# Ryan Information Bulletin

**Product Type: Jr. Sodcutter**

**Bulletin No: C-039-05**

## Rear Wheel Spacer

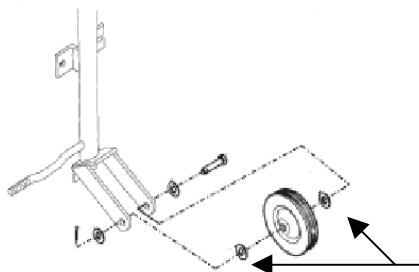
Rear Wheel not being held in place, allowing the bearing to be damaged.

Install 1 –2 spacers part number 64163-67 per side as shown in drawing, to shim rear wheel to forks within a 1/8" of play. Try to center wheel in between forks as much as possible.

Add here
